NRN
From: John Grobe
To: Eric Duncan
Date: Wed, May 9, 2007 10:09 AM
Subject: Fwd: FirstEnergy Nuclear Operating Company (FENOC) Exponent Failure Analysis Associates' Technical Report

The FirstEnergy Nuclear Operating Company (FENOC) docketed a May 2, 2007, letter responding to four specific issues raised by the NRC staff regarding the Exponent Failure Analysis Associates' technical report, "Review and Analysis of the Davis-Besse March 2002 Reactor Pressure Vessel Head Wastage Event." In the May 2nd letter, FENOC noted that they provided the Exponent report to NEI with a request that an evaluation be conducted to determine if the report calls into question the adequacy of the industry's operational monitoring or inspection programs or otherwise raise a potential generic safety concern.

**Effect of Exponent Analysis of
Davis-Besse Reactor Vessel Head Wastage Event
On Industry Inspection Programs**

Figure 2-1
Davis-Besse Crack Growth Rates Relative to MRP-55 Data

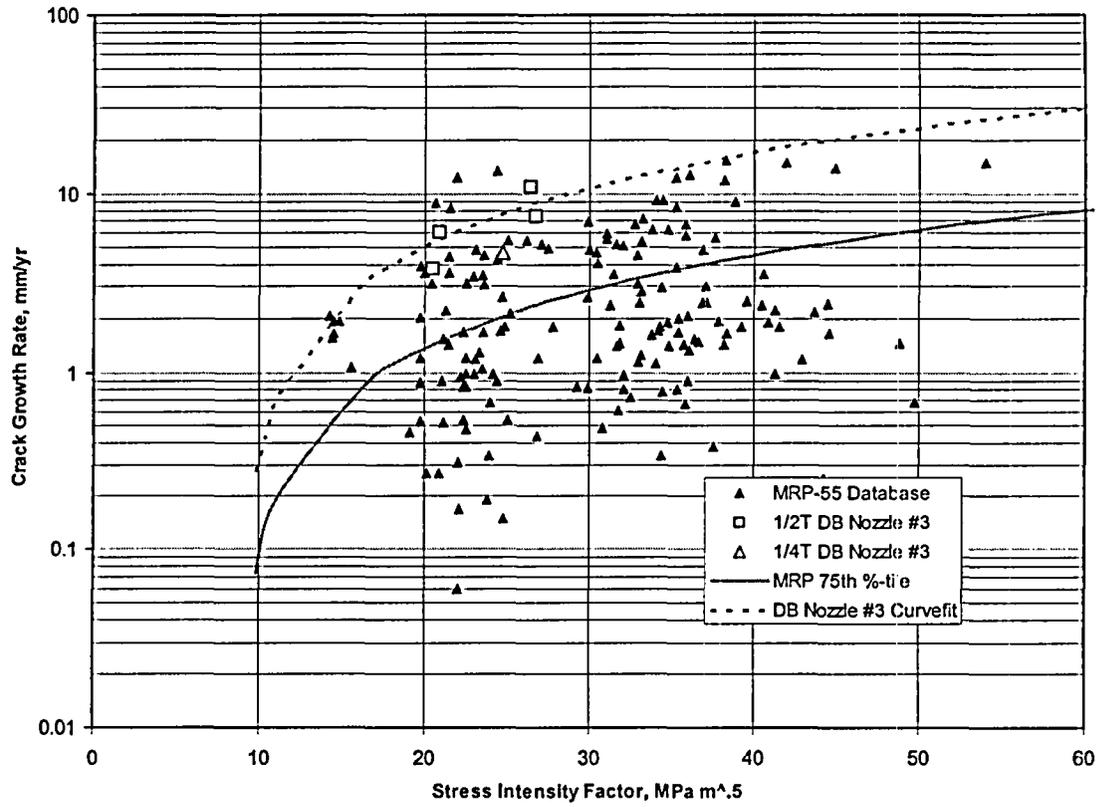
Exponent states that the crack growth rates of the Davis-Besse CRDM nozzle material were up to four times the growth rate of the MRP recommended 75th percentile crack growth curve reported in MRP-55. While this statement is correct, Figure 2-1 from MRP-55 shows that some of the material specimens in the MRP-55 database had crack growth rates even higher than the Davis-Besse material. Therefore, the Davis-Besse material is considered to be within the bounds of previously evaluated materials.

Figure 2-2
Projected Crack Growth and Industry Examination Requirements for a High Temperature Head under Crack Growth Rate Conditions Postulated in Exponent Report

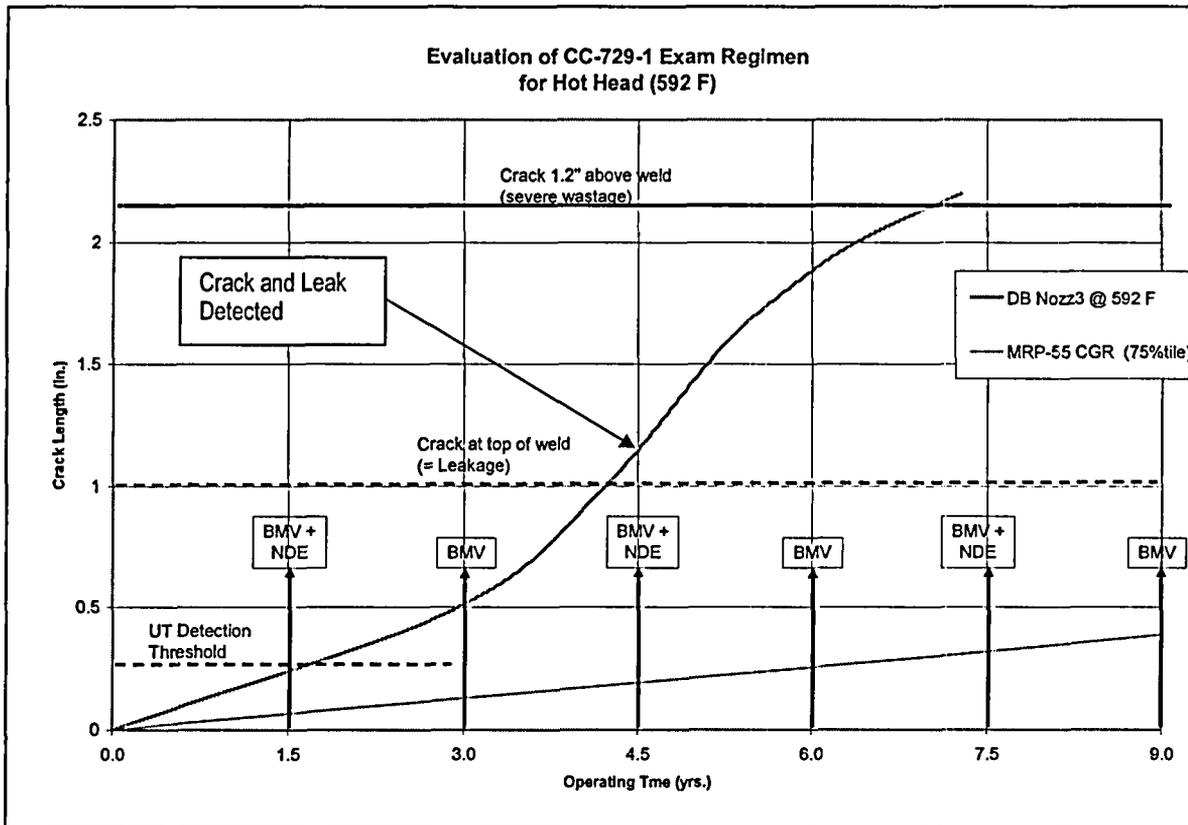
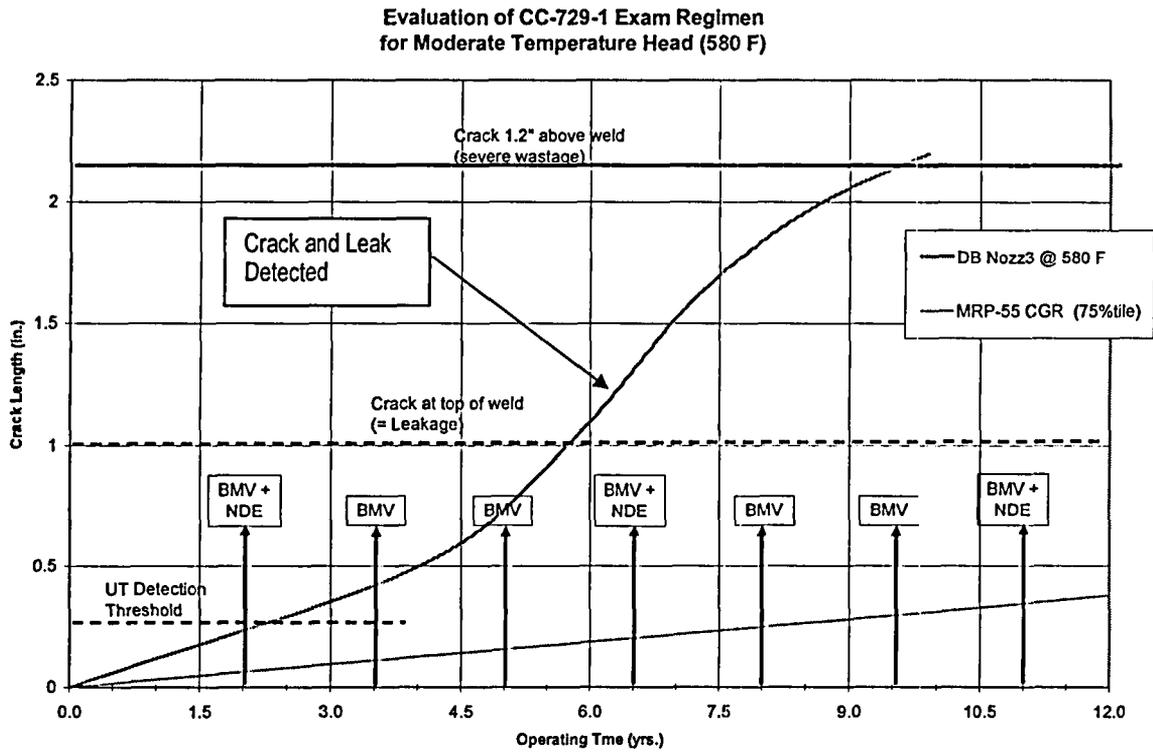
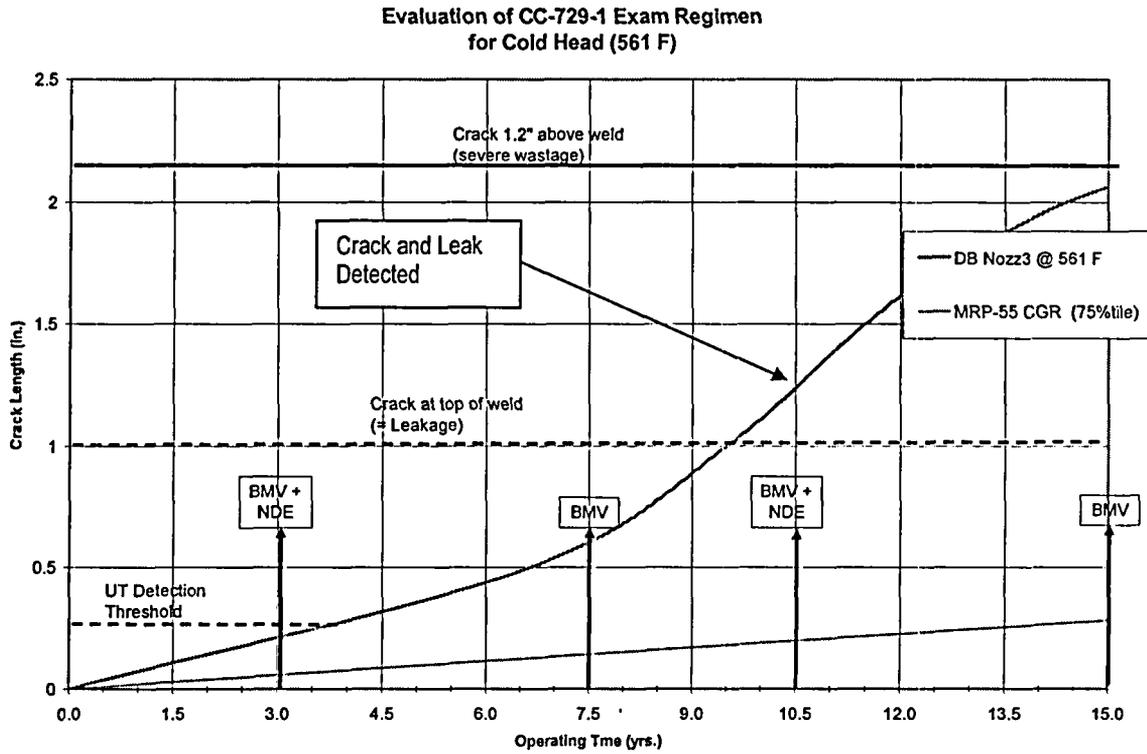
Deterministic predictions of crack growth for the three sample cases, using the crack growth rate curve for Davis-Besse Nozzle 3 referenced in the Exponent report are presented in Figures 2-2, 2-3 and 2-4. In each case, the crack growth rate equation was adjusted to the appropriate head operating temperature in accordance with the Arrhenius equation for crack growth (MRP-55¹). The figures also show the predicted crack growth in accordance with the MRP-55 75th percentile crack growth law for comparison purposes. Several significant crack sizes are shown as horizontal dashed lines on the figures, corresponding to the crack length at which detection by UT would be expected with high confidence (conservatively assumed = 0.25"), the crack length corresponding to the crack at the top of the weld, at which leakage is predicted, and a crack length of 1.2" above the weld, corresponding to the crack length that was discovered at Davis-Besse in 2002. Finally, vertical arrows are plotted on the figures corresponding to the NDE and BMV inspections that would be required at various refueling outages, per Table 2-1 above. Since inspections required per the NRC Order are somewhat more conservative than those required by Code Case N-729-1, only those required per the Code Case are shown on the figures. This produces the most conservative evaluation of the potential effect of the Exponent crack growth rate, since it corresponds to the least amount of inspection that would possibly be performed in the future. Also for conservatism, the initial baseline inspection was assumed to occur at a time when the postulated crack is just below the UT inspection threshold, and would thus be missed.

Figures 2-2 through 2-4 show that for each hypothetical case an NDE + BMV would be performed shortly after the postulated cracks are projected to reach the top of the welds, such that they would be well above the detection threshold of the ultrasonic NDE, and evidence of leakage would likely be detected by the BMV as well. These exams would be performed, and the cracking detected, well before the crack length approached the size predicted to have caused the severe wastage observed in the Davis-Besse head. These results, plus the conservative bounding nature of the deterministic evaluation, were a major factor in the panel's conclusion regarding adequacy of the current industry RPV top head examination program.
